Date: August 15, 2018
To: Cumberland Planning Board
From: Carla Nixon, Town Planner
Subject: OceanView at Cumberland Major Subdivision Final Review

Date August 15, 2018
To Town of Cumberland Planning Board
From Carla Nixon, Town Planner
Subject **Major 52 Unit Major Subdivision, Final Review: OceanView at Cumberland – 277 Tuttle Road**

Subject: Planner's Comments for Ocean View

C29

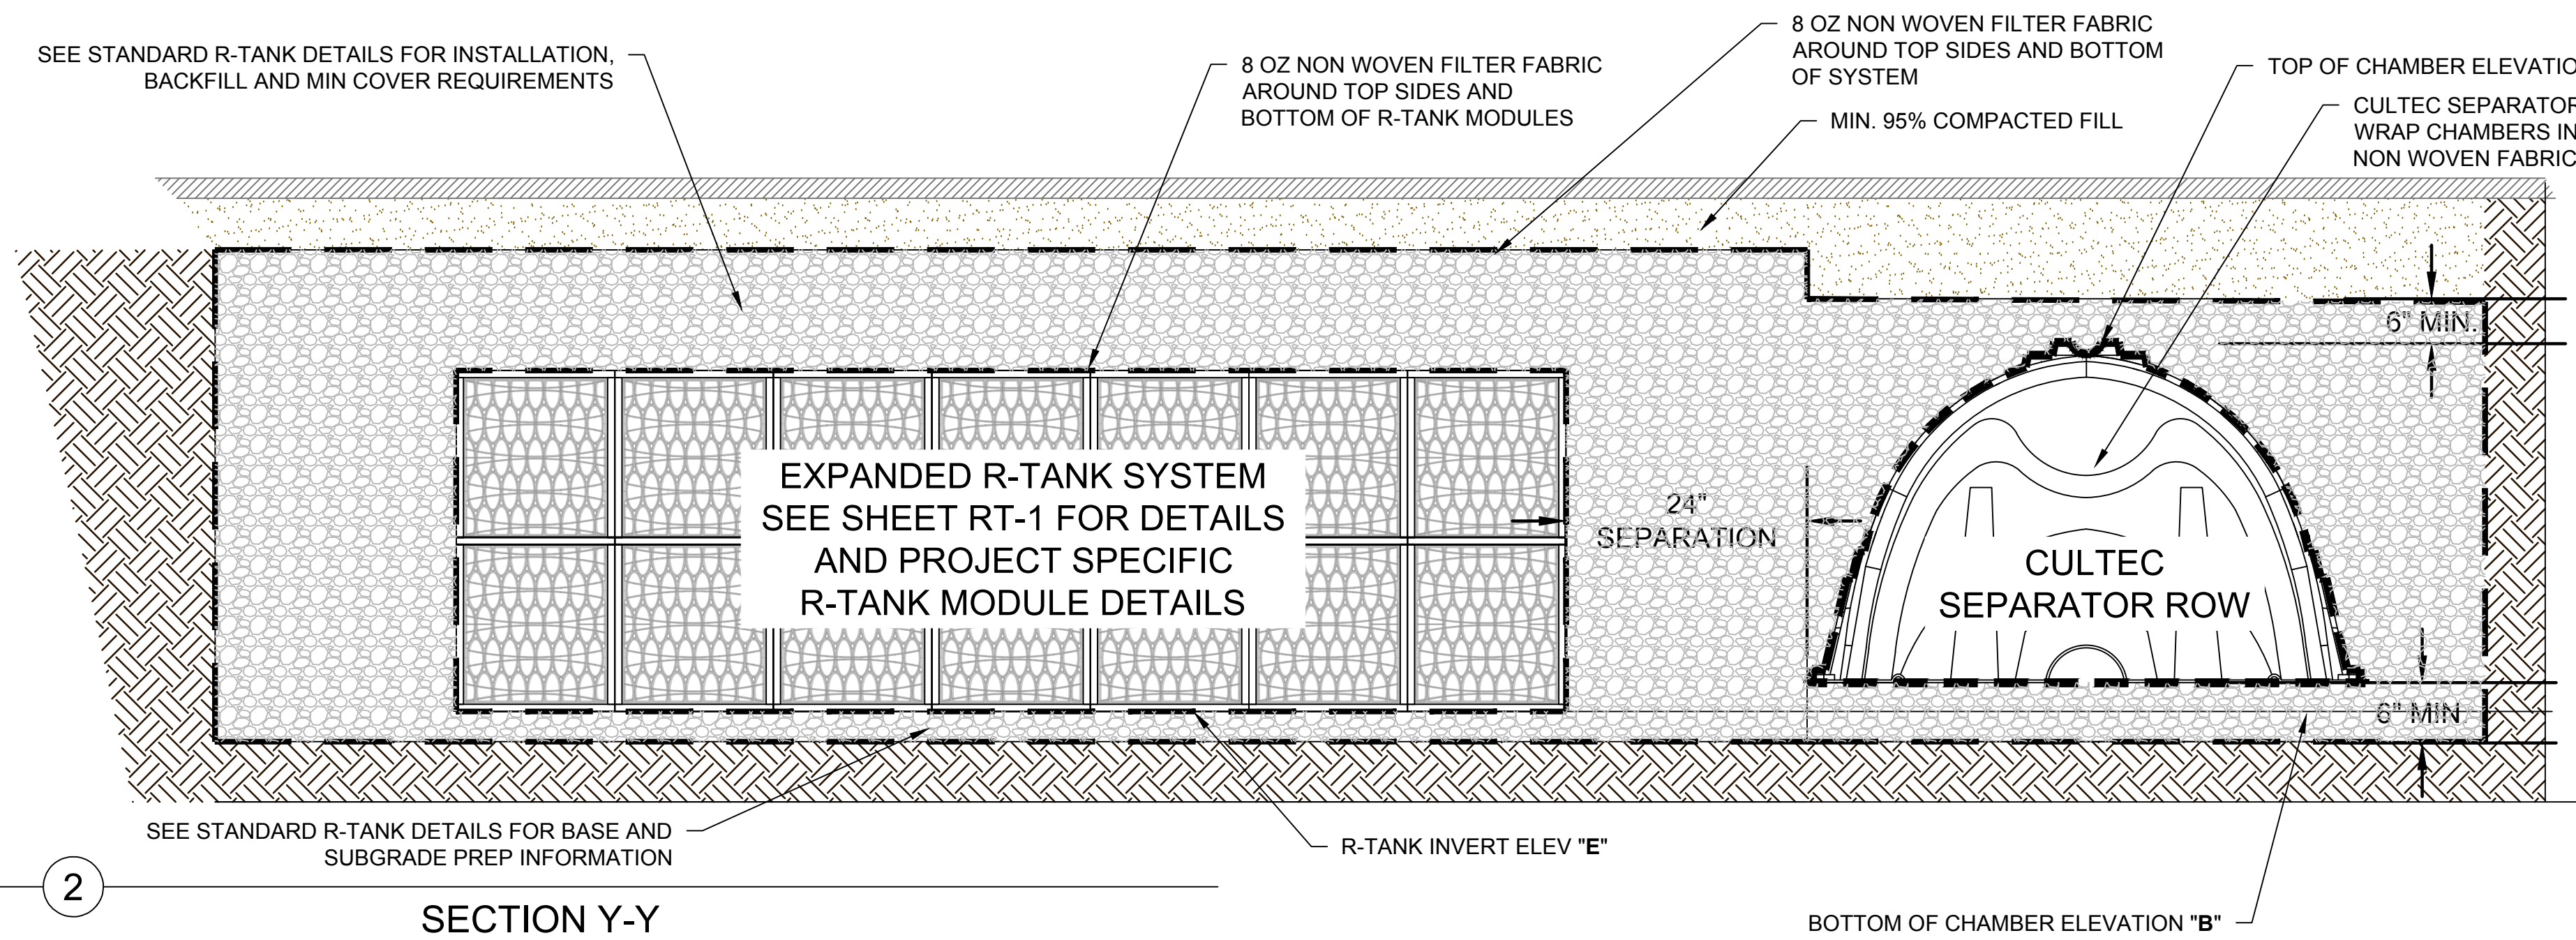
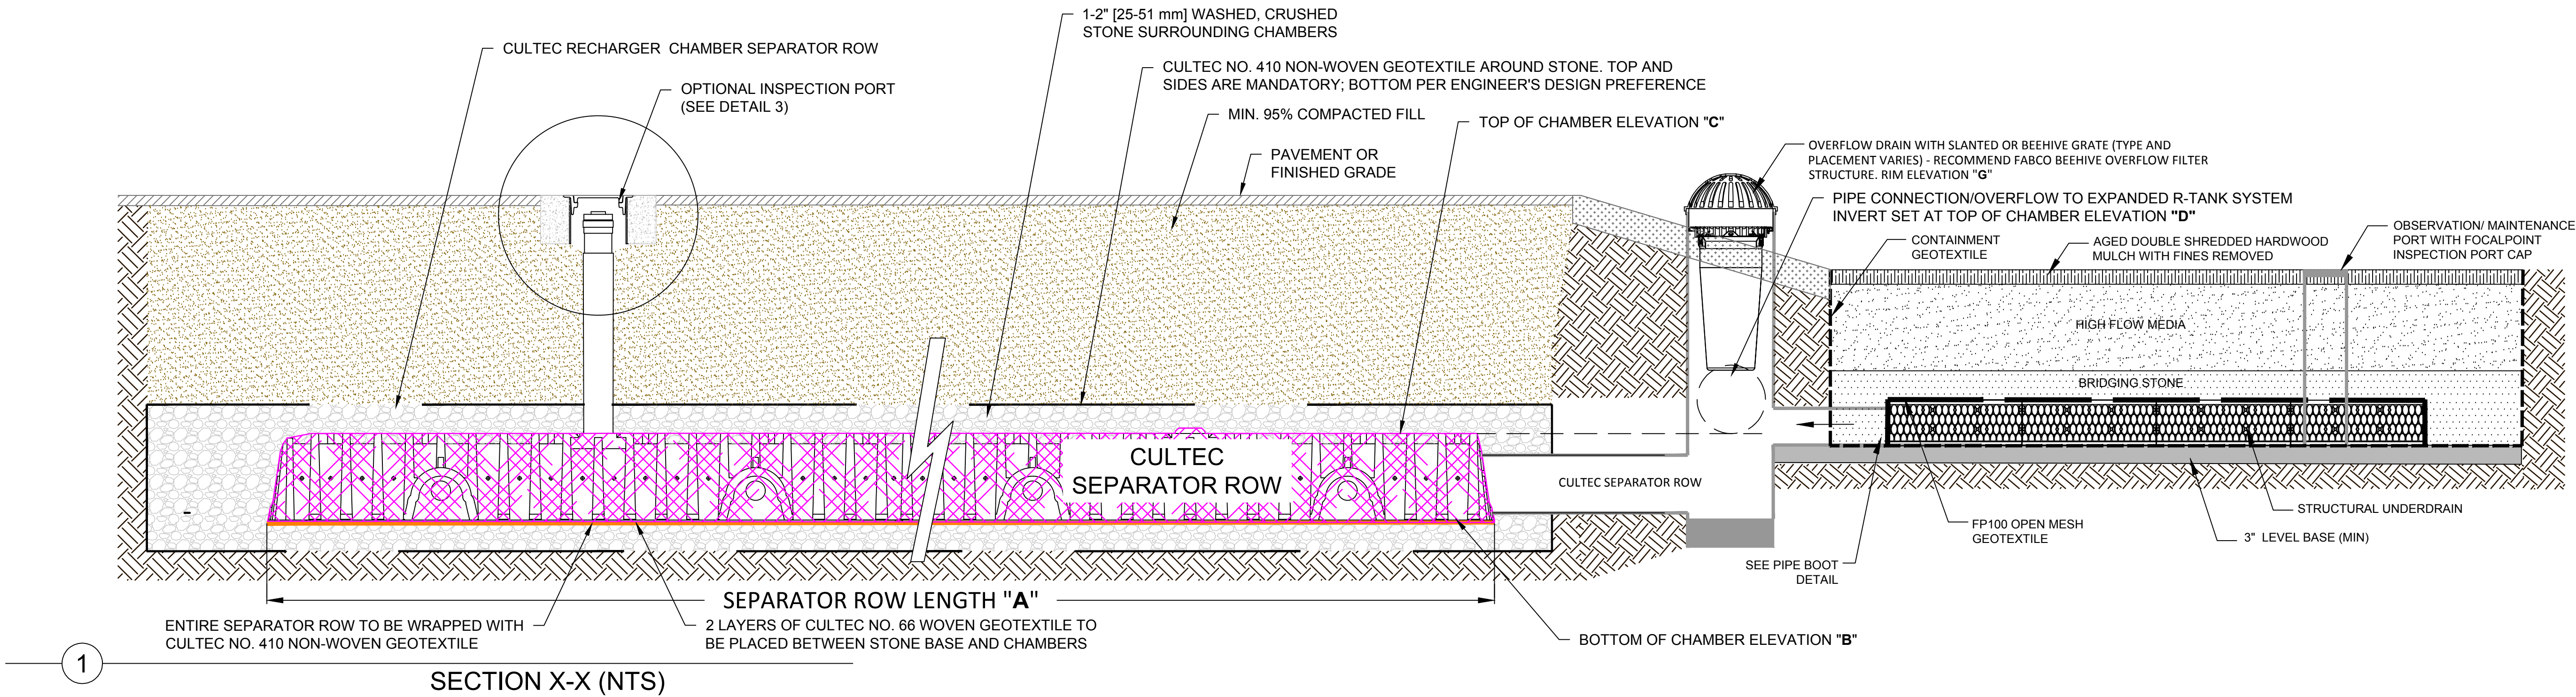
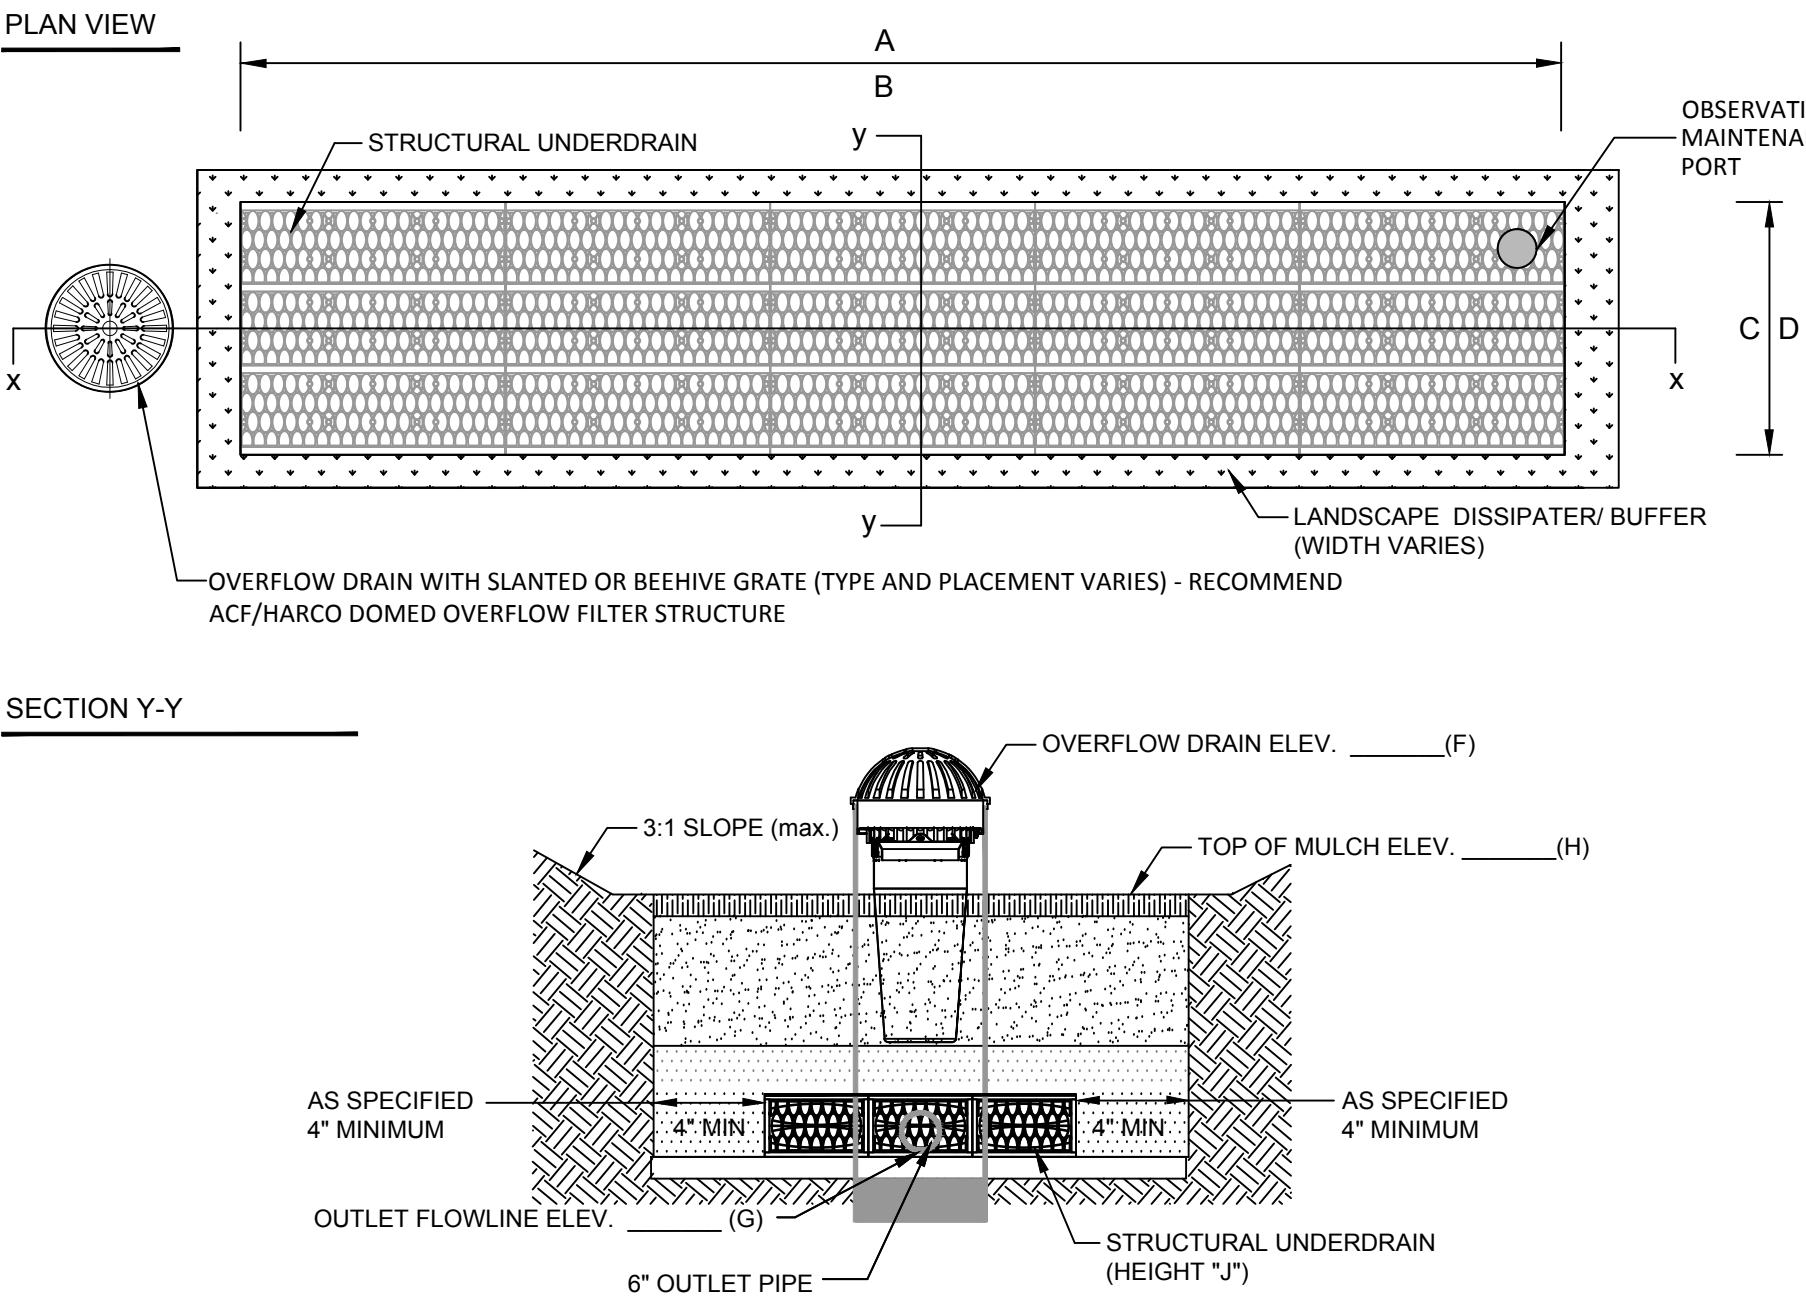
39. Sheet C-28, R-Tank dimensional data for FP-2 is incomplete.

SHEET NAME:		SHEET:	
Site - Photometric Layout	Checked By: G.MANCINI	Date: 02.22.2018	ES1
	Drawn By: A.AMES	Scale: 1" = 100'-0"

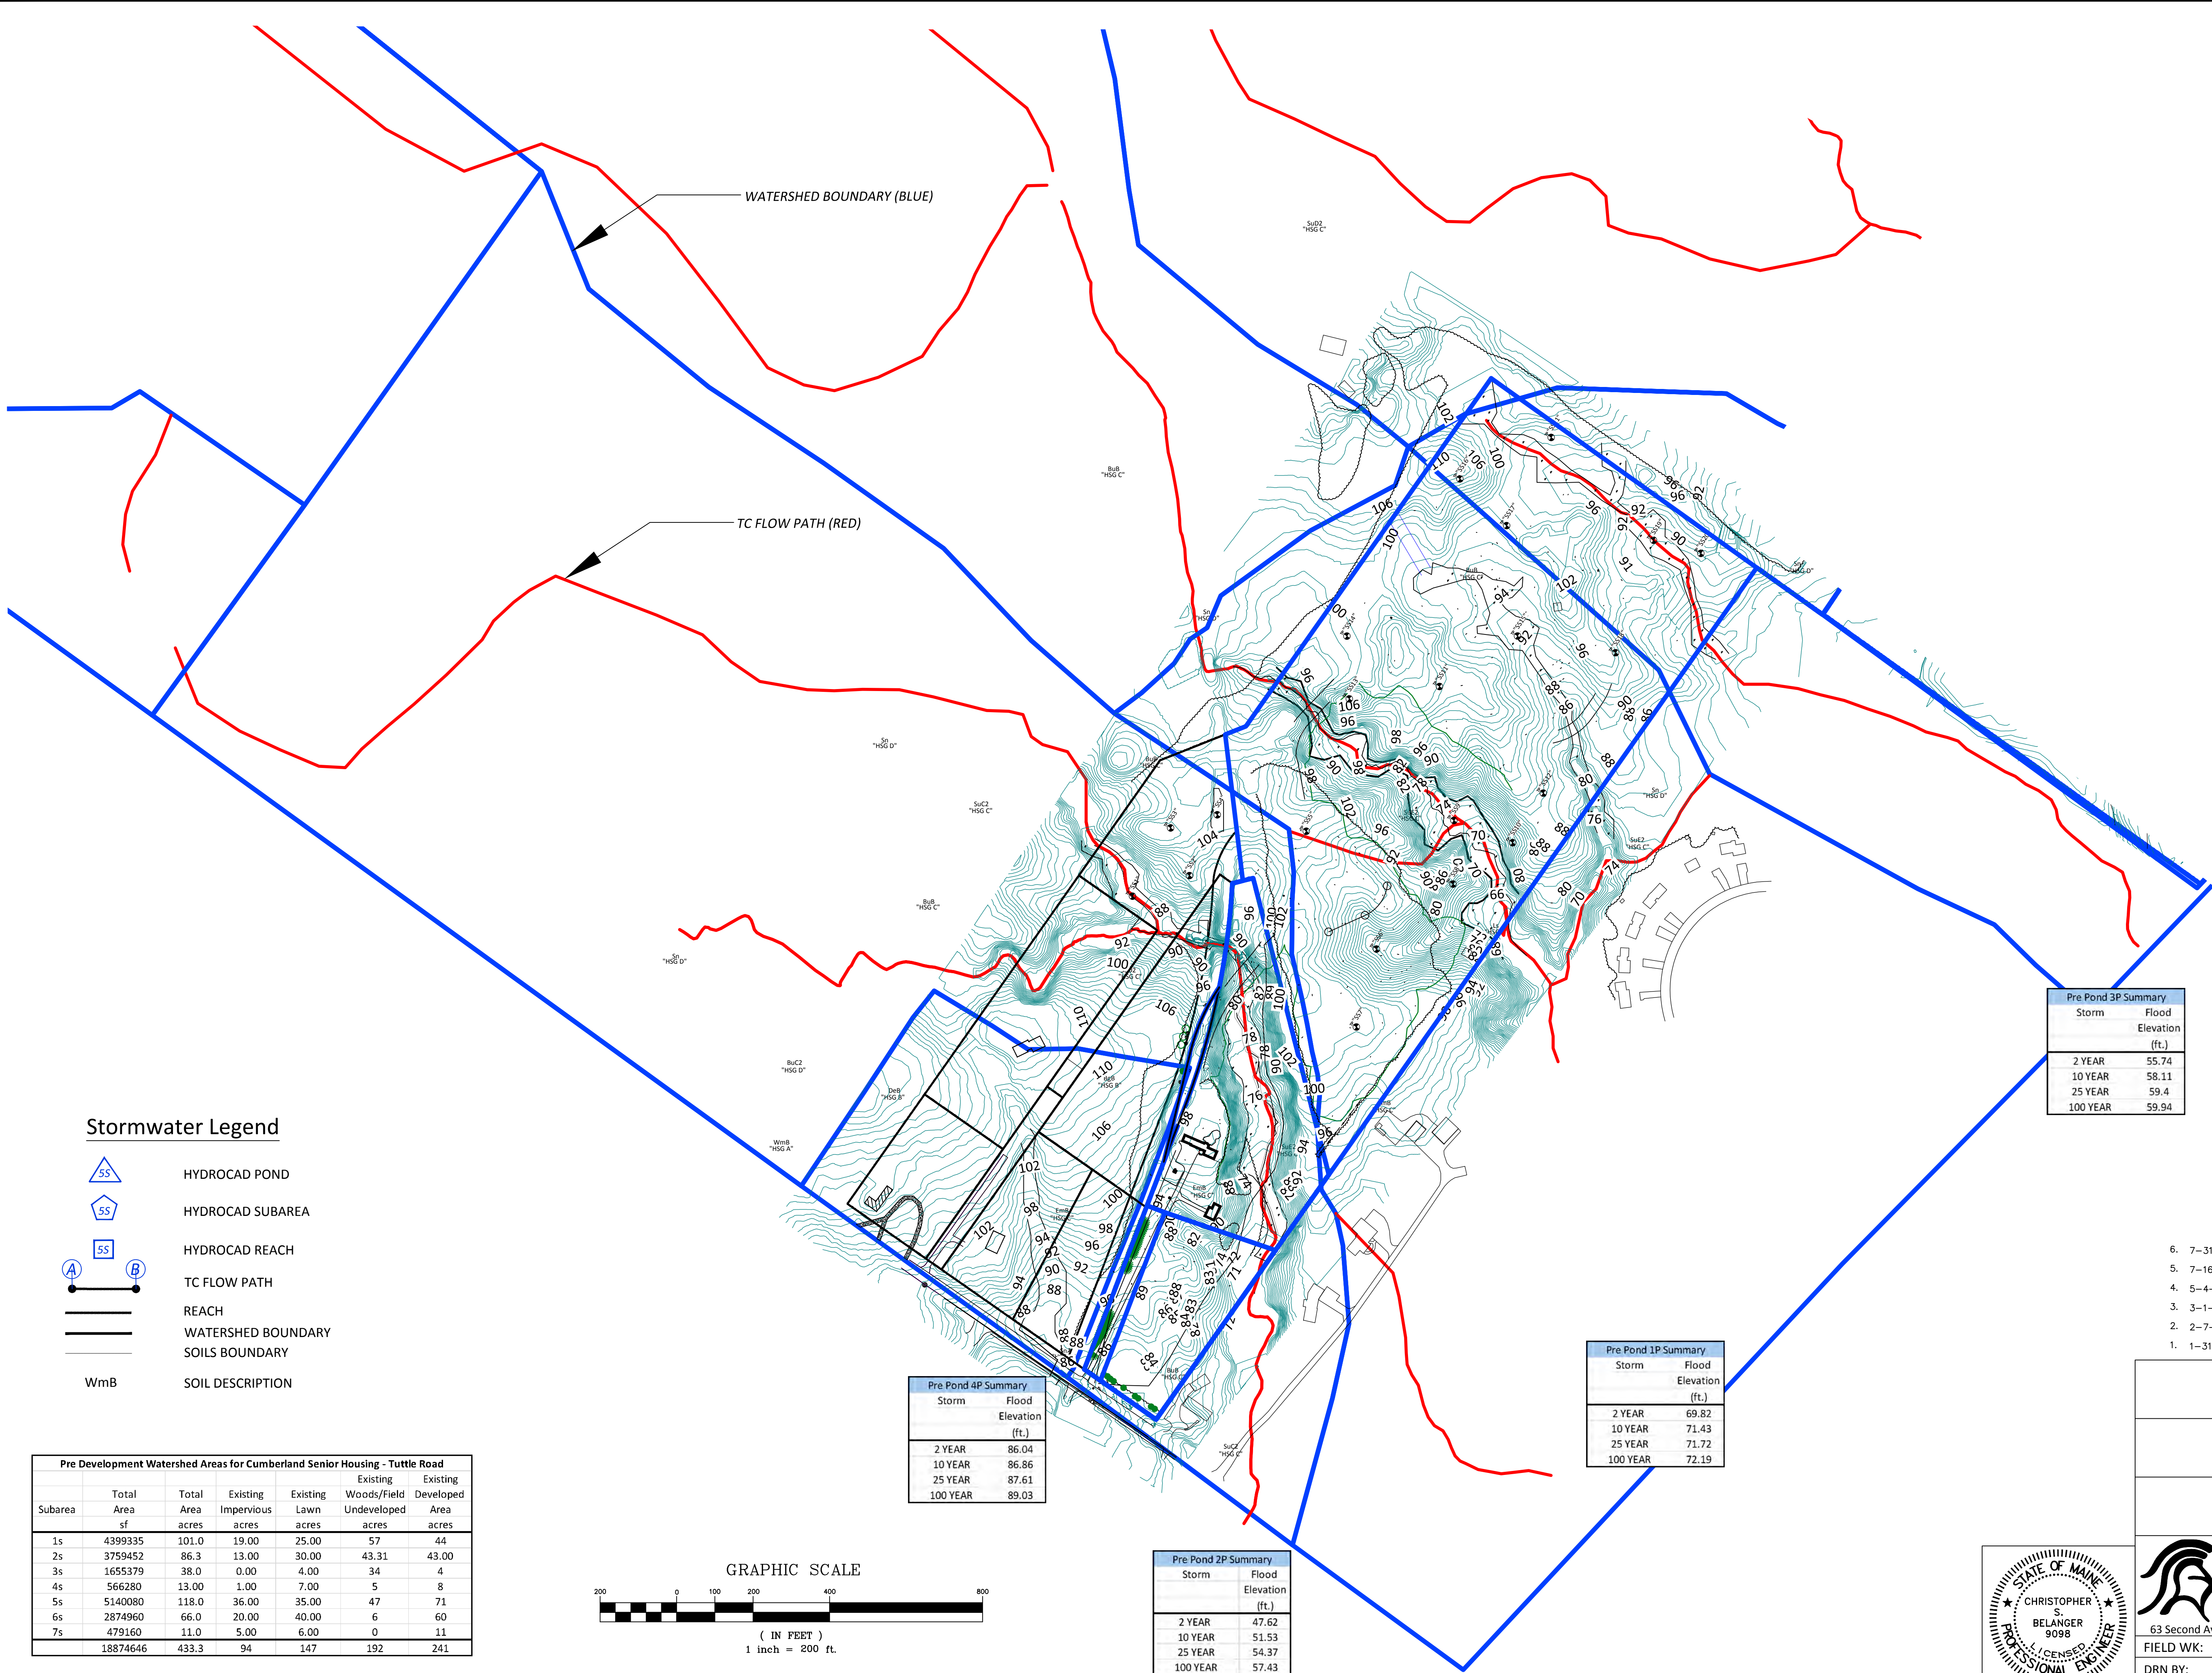
1. Photometric plan missing. Light fixture locations are shown on plans and appear to be excessive with overhead street lights, front lawn pole lights and wall mounted lights at each unit door entrance. Night Sky concerns? Carla: We omitted Plan ES-1 Photometric Plan as an oversight. It was included in the Prelim Plan Set. See copy attached. The focus is indeed on Dark Sky ideals. The Beacon Full-Cut off Street Fixtures with LED lights meet the IDA cut off standards. The Individual driveway lights while not cut off are low wattage and provide ambient night lighting without creating a large "glare". The residents of OceanView Falmouth have found these to be pleasing. The wall mounts at the front entry are typical for any home and are recessed into the ceiling so there is no spillover and the other light fixture matching the post light is mounted at the garage. Again very subtle. The unit lights do not create spillover beyond the unit itself.

We will add the Photometric Plan Es-1 to the Town Link for the Final Plan Submission.
2. Typos noticed in the following locations: Note 16 on S-4 ("does includes"); Sheets C33 and 34 (Portland Water District"). We will fix typos for the final Mylar. Thanks for picking up.
